NABI Service Bulletin No: SB-13-11-02

Subject: Updated ZF Transmission Shift Selector part no. 6006 341 036

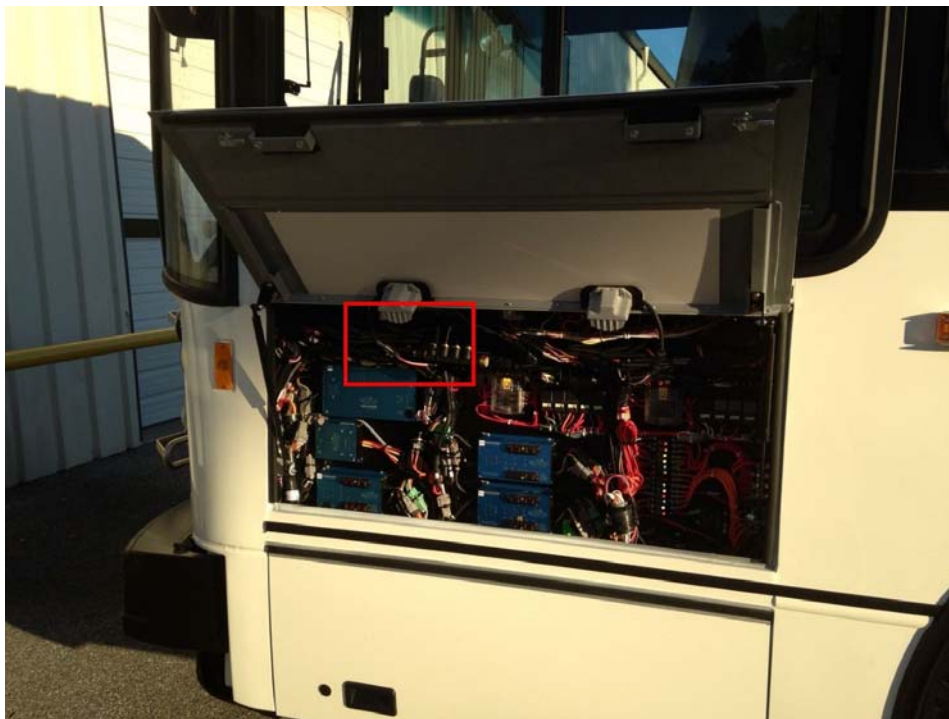
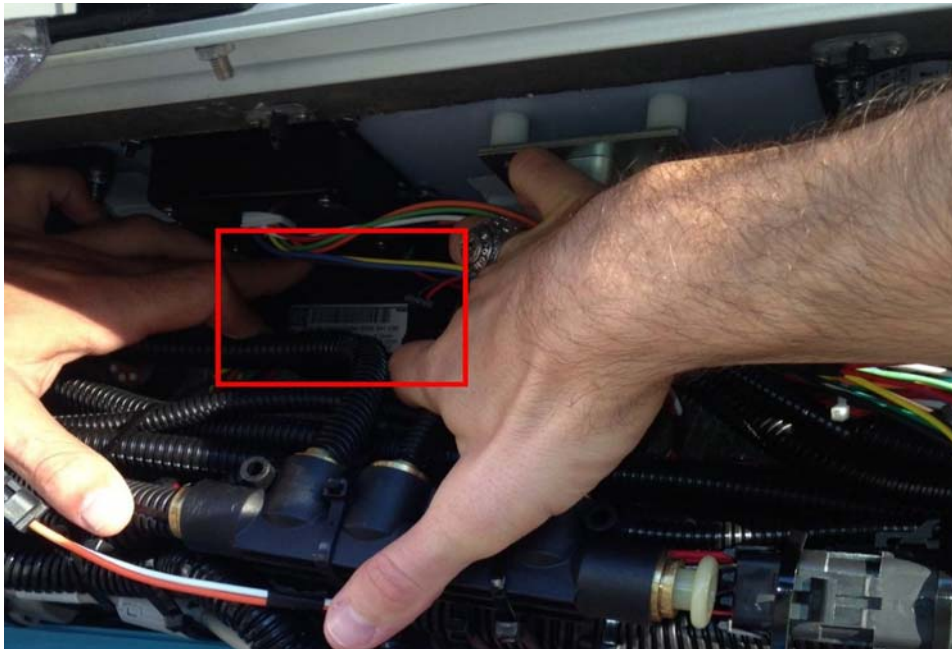
ZF has released an updated version of its Eco-Life Shift Selector with the part number 6006.341.036. While the part number has not changed, the updated shift selector is easily identifiable by the “HW” number on the part’s ID tag. The updated shift selector has the Number HW: 0004.

The shift selector is found in the compartment directly below the driver’s window. See the pictures below for the location:

Earlier versions of the shift selector will have the number HW: 0001, 0002, or 0003.

Earlier versions of this selector in stock should be returned through normal parts return processes. Shift selectors that have been removed and replaced with this updated version should be returned to the following location:
